**LEBANON PLANNING BOARD
MAY 12, 2025 - 6:30 PM
COUNCIL CHAMBERS, CITY HALL OR
REMOTE VIA VIRTUAL PLATFORM
LEBANONNH.GOV/LIVE**

CITY OF LEBANON ~ PLANNING & DEVELOPMENT

Staff Memorandum – PB2025-21-SPR

PROPOSED SEWER FORCE MAIN, STA. 4+20 - 6+80
SCALE: 1" = 10'

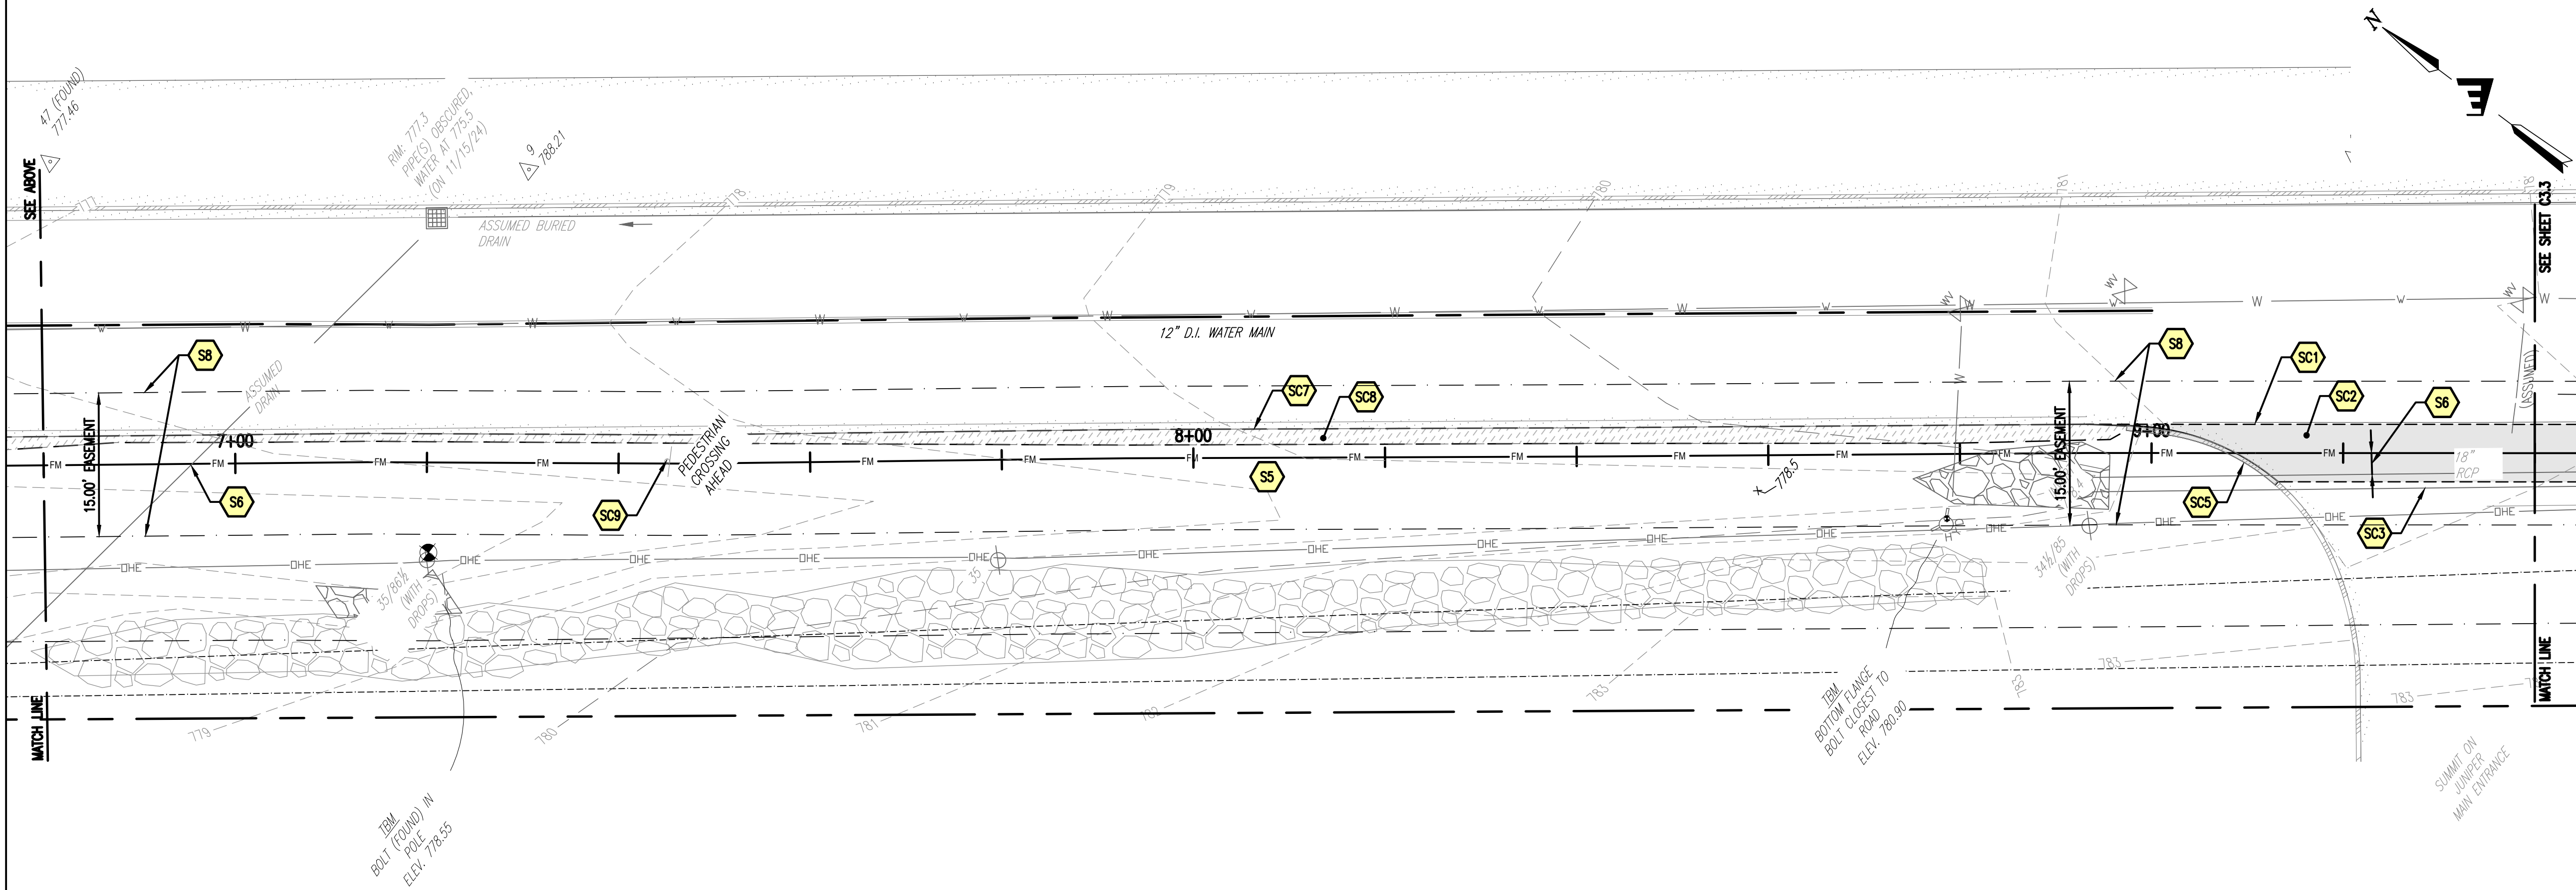
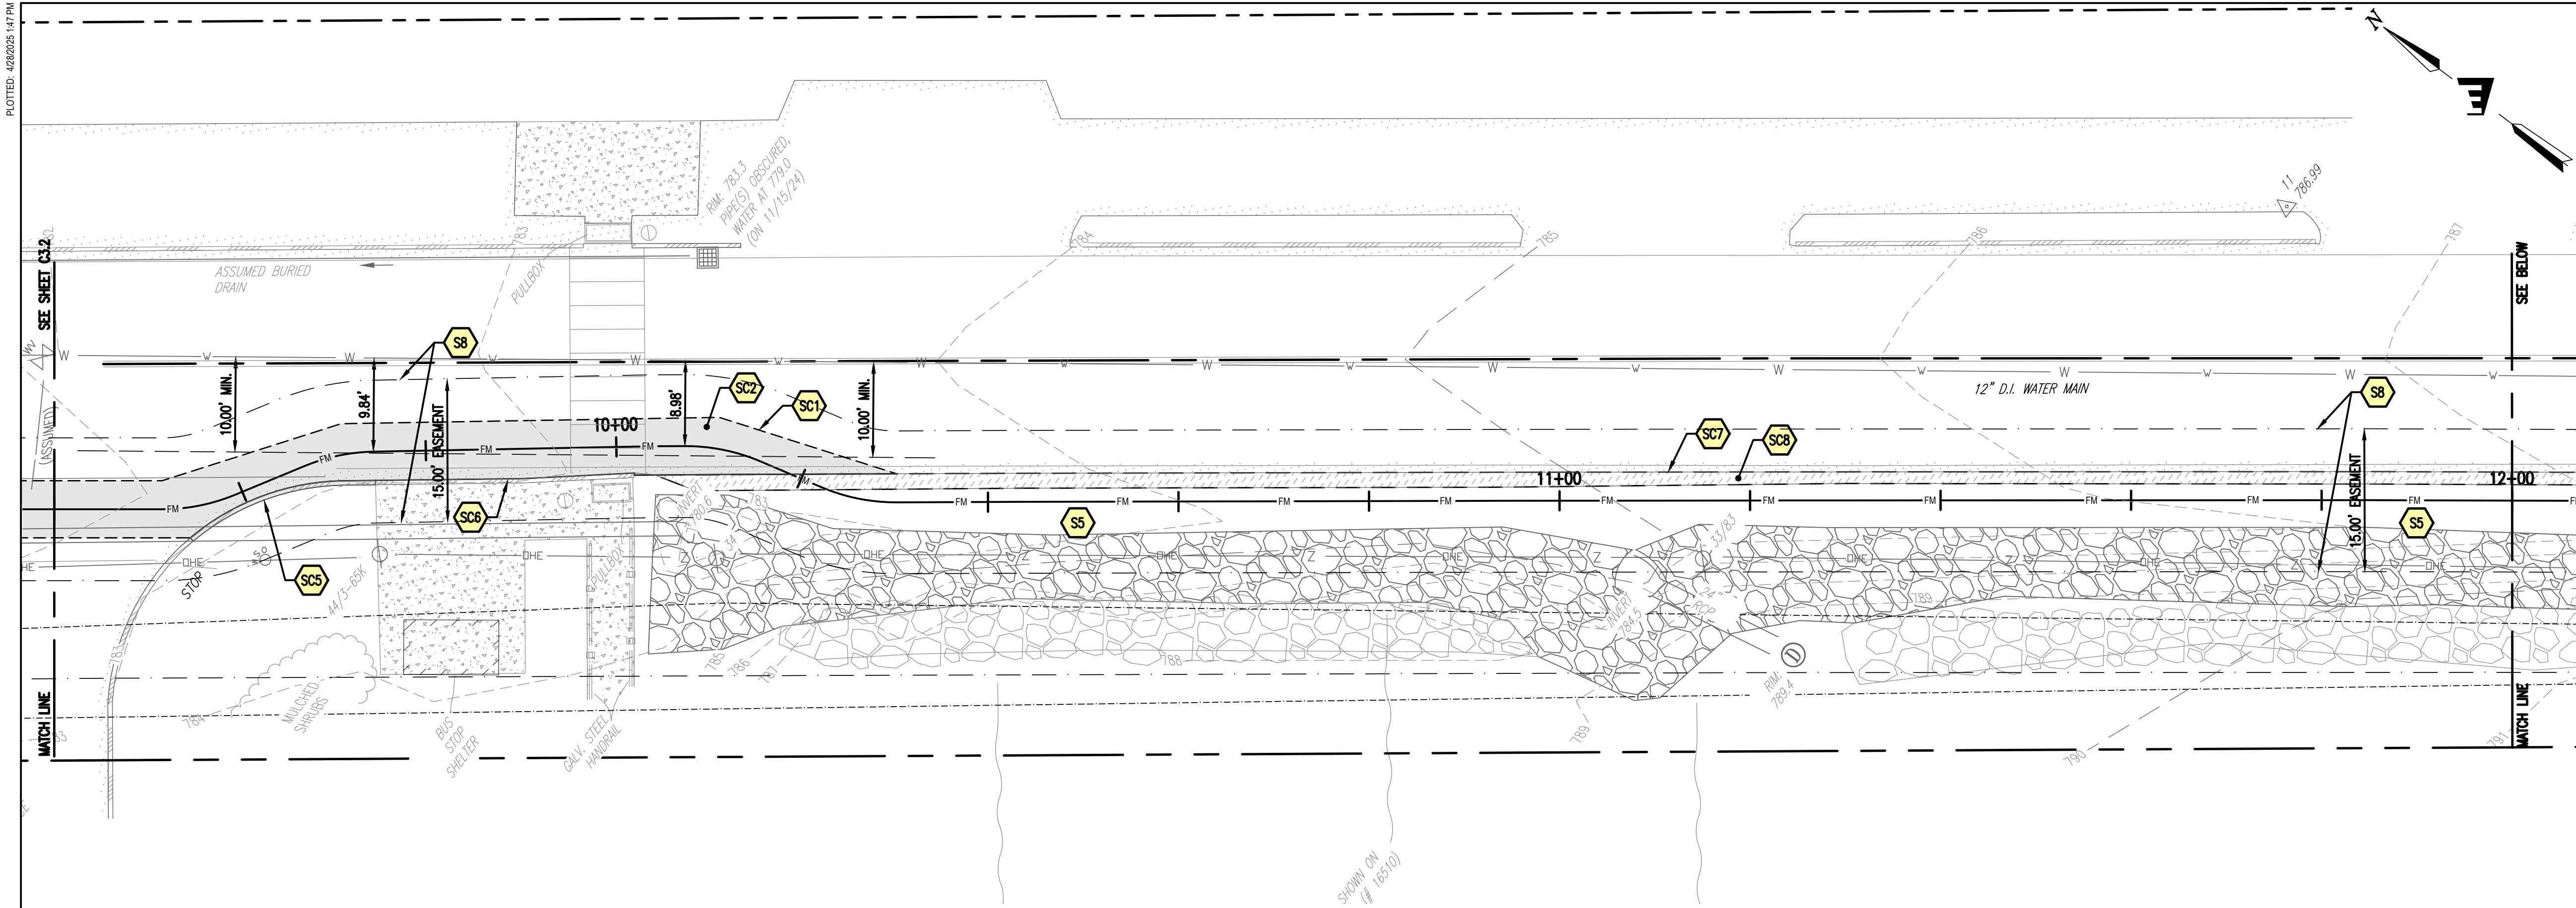
13. *The anticipated easements referenced in planning staff comments 2 and 3 above should be shown in the plan set.*
 - Sheets C3.1 through C3.3 now show a proposed easement for the sewer line. The easement will be finalized, and the plans adjusted if needed, prior to the issuance of a building permit.

- Sheets C3.1 through C3.3 now include notes indicating that the property owner will retain ownership of the sewer line and that an easement between the property owner and City will be created following Site Plan Approval.

- Section 5.1.E.22 implies that the easement is to be shown on the plans. Sheets C3.1 through C3.3 now show a proposed easement for the sewer line. The easement will be finalized, and the plans adjusted if needed, prior to the issuance of a building permit.

① North Elevation
1/8" = 1'-0"

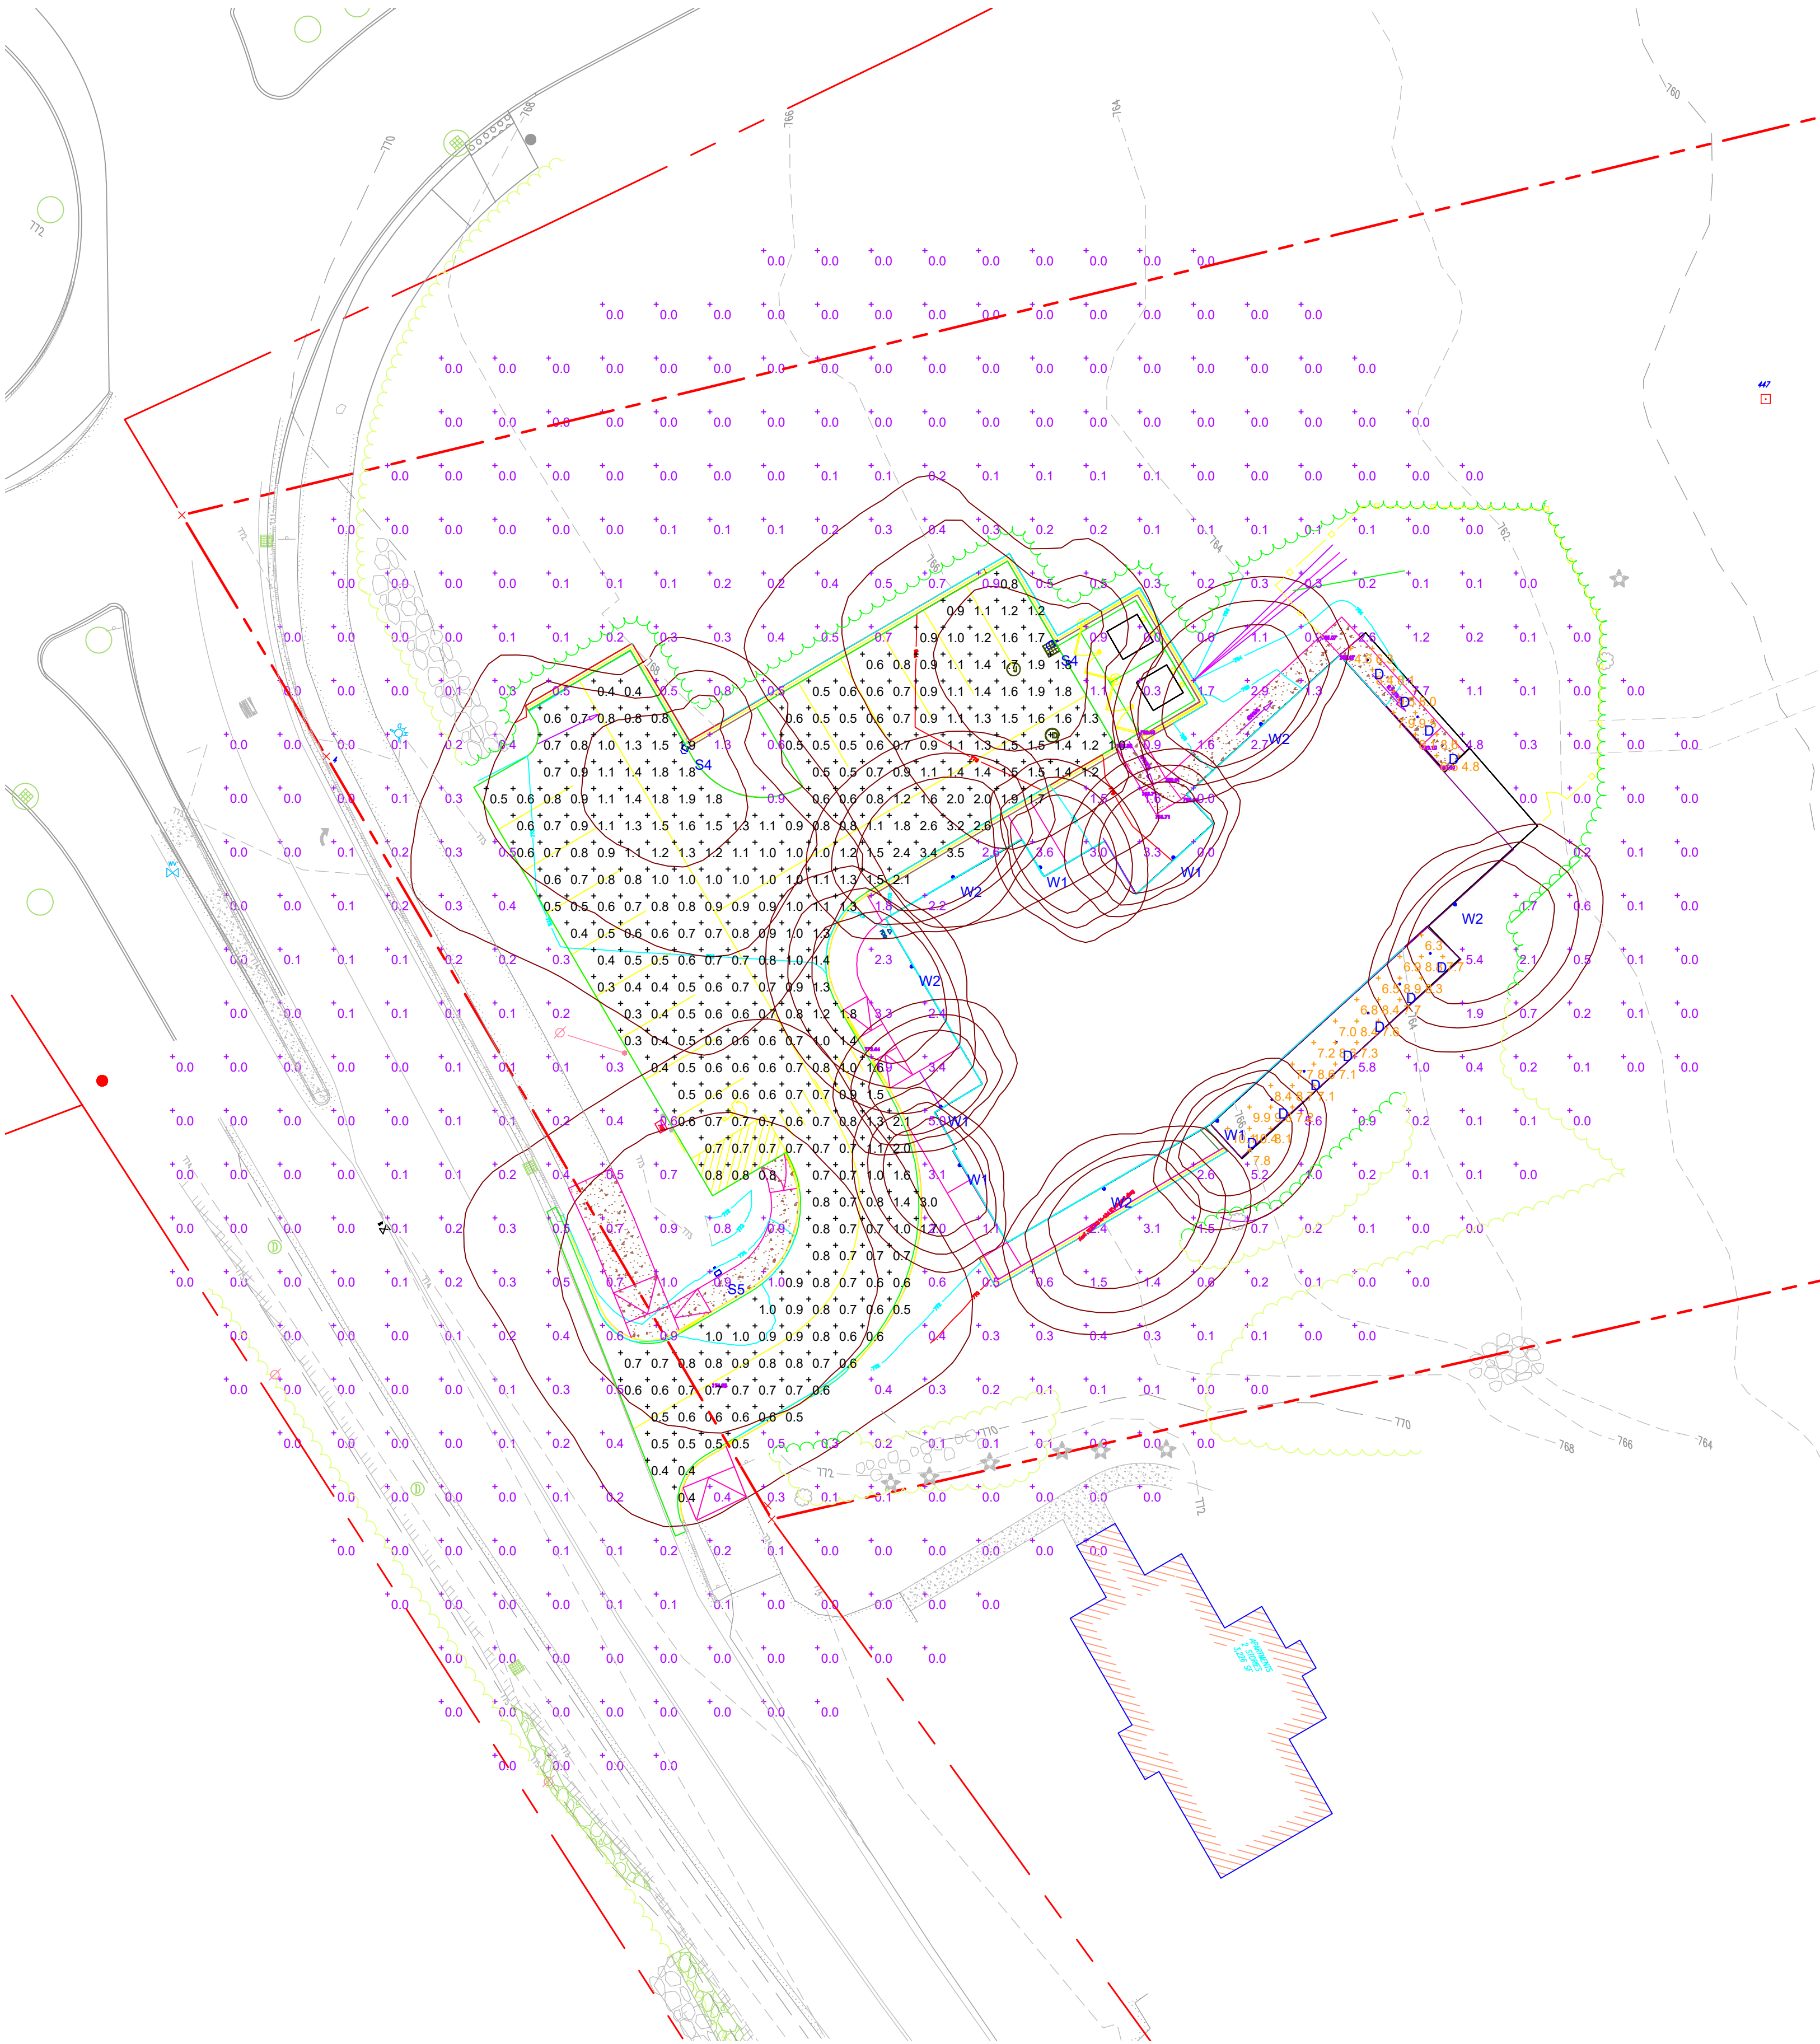
- As shown on the building elevations in the revised plan set, the vertical distance to the eave is below 30 feet.
2. *Please show the nearest fire hydrant to the site on the plan set.*
 - The existing new hydrant is now shown just northwest of the limits-of-disturbance on sheets C1.1 through C2.4.
 3. *Please provide a sheet showing AutoTurn movements based upon the dimensions of the Lebanon fire apparatus.*
 - Vehicle Turning Analysis exhibits are included with the supplemental information of this resubmission.
